HISTORIC DOWNTOWN ADVISORY COMMISSION

1. CERTIFICATE OF APPROPRIATENESS

Applicant: Mathew Althouse
Location: 26 W Olentangy Street
Existing Zoning: Downtown Business District (DB)
Request: To review a proposal to renovate an existing building for the purposes of a restaurant.

Site Considerations (Page 10)

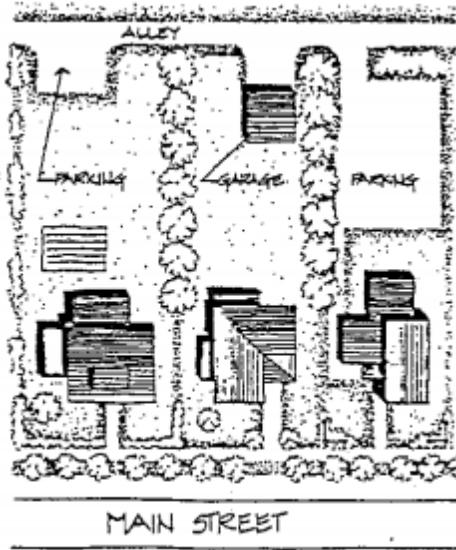
- The proposed project is in line with site considerations of the PAG.
 - Access to rear yard parking lots and storage or garage buildings should be from alleys whenever possible.
 - The proposal has designed their parking lot in this fashion.
 - Commercial lots should be paved with asphalt, brick, concrete, or tar and chips as required in the Powell Zoning Code.
 - Renderings show an asphalt type of pavement.

Architectural Elements (Page 46)

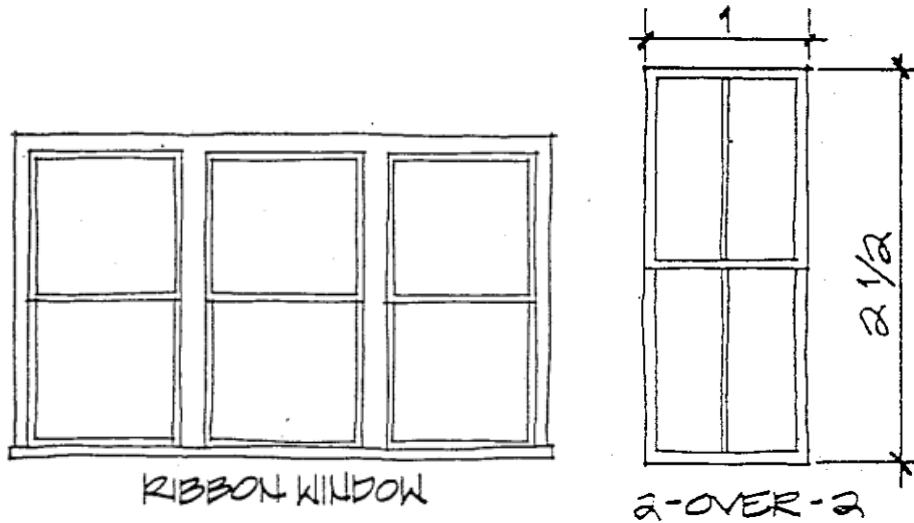
- The proposed project is somewhat in line with the PAG.
 - The front elevation of the proposal displays the Ribbon style, one of the three historically correct window styles with a 2-over-2 pattern. (Page 48)
 - Further examination by the Powell Architectural Advisor and HDAC is needed to determine whether the panels above the front windows is appropriate.

- Cornices used in new construction need not be exact duplicates of those existing in Powell. A simplified version which reflects the scale, substance and rhythm of typical City cornices will be appropriate. (Page 67)
 - The cornices selected seem to match others found in Powell.

- A palette of generally darker colors with a few of the earlier, lighter colors persisting. More vivid contrast, and “picking out” of details is prevalent. (Page 73)
 - The selected green color were selected from a historic color palette and match other buildings within the downtown.
